# **Additional Information**

**QUORN PARK SOLAR FARM**

Report No: 217510\_VIS

This report has been prepared by Premise Australia Pty Ltd on behalf of Quorn Park Solar Farm Pty Ltd to provide additional information to Department of Planning Industry and Environment (DPIE) with regard to the extent of visual impacts of Quorn Park Solar Farm (QPSF) on all potentially impacted non-associated receivers and the potential impacts of the project on downstream flows and flooding. This document supports the Environmental Impact Statement dated October 2019 and subsequent responses to queries already provided to DPIE.

Figure 5 – Development Footprint & Substation Location

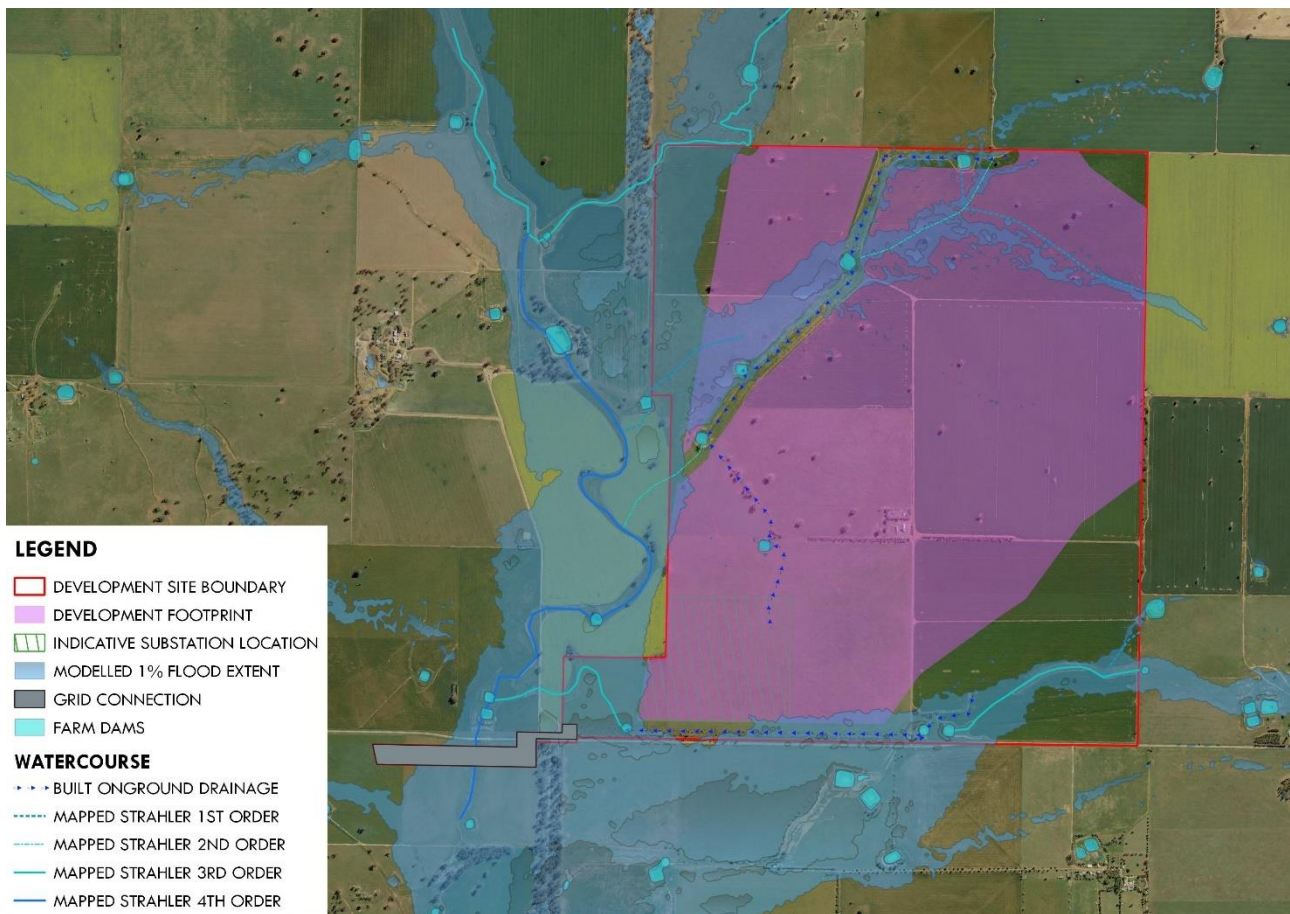
Surface Water: provide additional information regarding the potential impacts of the project on downstream flows and flooding, particularly regarding the infrastructure proposed in the south-western portion of the site (including the on-site substation), including measures proposed at all stages of the development to mitigate and manage surface water runoff.

It is important to confirm that the substation and battery storage will avoid flooding. Hence the Premise hydrologist modelled the flow of stormwater across the site for the 1 in 100 year storm event (1% Average Exceedance Probability, AEP). The details of the modelling follow in section 3.2. The modelling demonstrates that the area identified for the substation and battery storage site is clear of flooding.

The substation and battery storage have been located on flood free land. Therefore impacts on downstream flows will not be significant. **Figure 5** shows the development extents and substation location being outside the flooded area.

In response to submissions mentioning the potential for impact on downstream water flows and flooding due to infrastructure in the south western portion of the site, the development footprint has been reduced. In the modified development footprint there will be no infrastructure on the western side of the existing overhead line, with the exception of the grid connection. This applies in the north western and the south western corners of the site. Refer to **Appendix A** for the modified Development Footprint.

Figure 1 – Modified Development Footprint

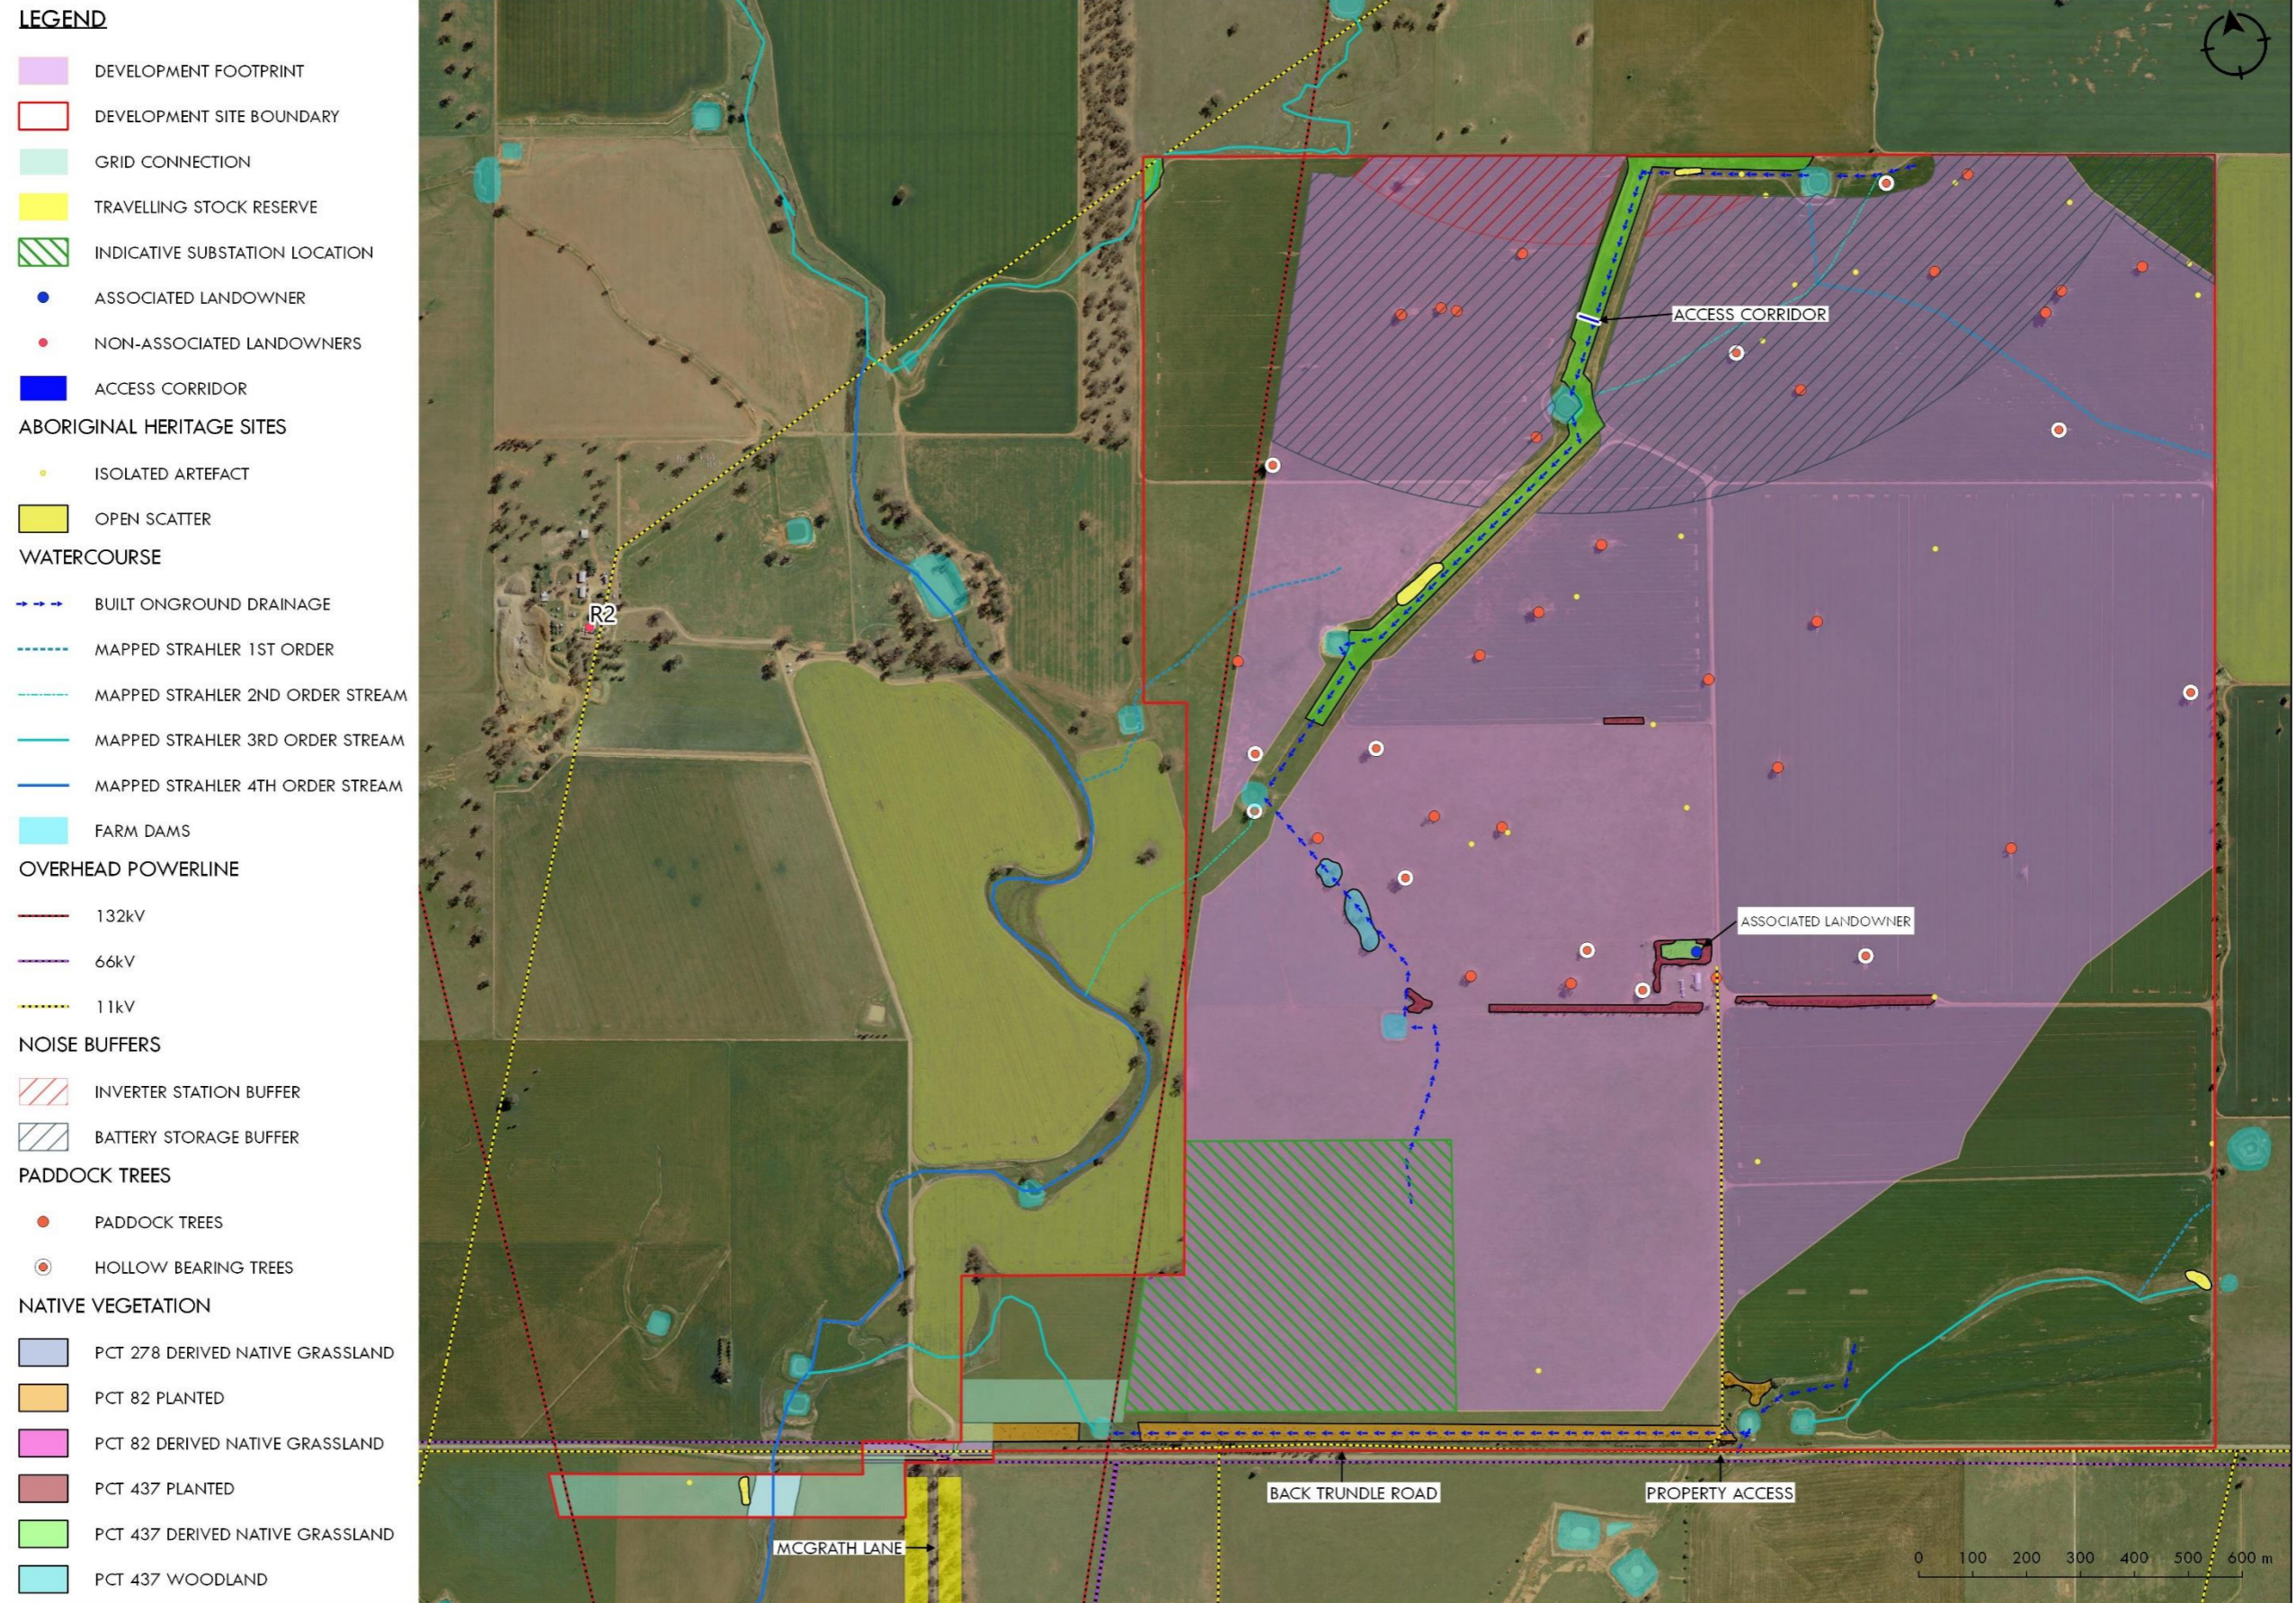
Visual: Provide further assessment detailing how the proposal has considered the full extent of visual impacts on all potentially impacted non-associated receivers including:

The development footprint has been modified to provide additional setbacks for neighbours who have raised concerns about visual impact. The details have been identified in the prior sections where each affected residence is assessed. The area cut from the development footprint with these additional setbacks is 57 hectares. The modified development footprint area is now 354 hectares compared to the development site area of 470 hectares, excluding the grid connection area.

In the modified layout, in relation to receiver R2, no solar farm infrastructure, with the exception of the grid connection, would be located west of the existing 132 kV overhead power line that traverses the development site. This will provide a setback for R2 of at least 1,200m to the solar farm development footprint. Since the final layout will occupy only a portion of the development footprint, the actual setback is likely to be greater.

For receivers R8, R9 and R11 the development footprint has been modified to provide a setback of 1,200m from the solar farm development footprint to each of these residences. Since the final layout will occupy only a portion of the development footprint, the actual setback is likely to be greater. These setbacks modify the development footprint in the north east corner for R9 and in the south east corner for R8 and R11.

Refer **Appendix A** for the modified Development Footprint which shows the new setbacks.
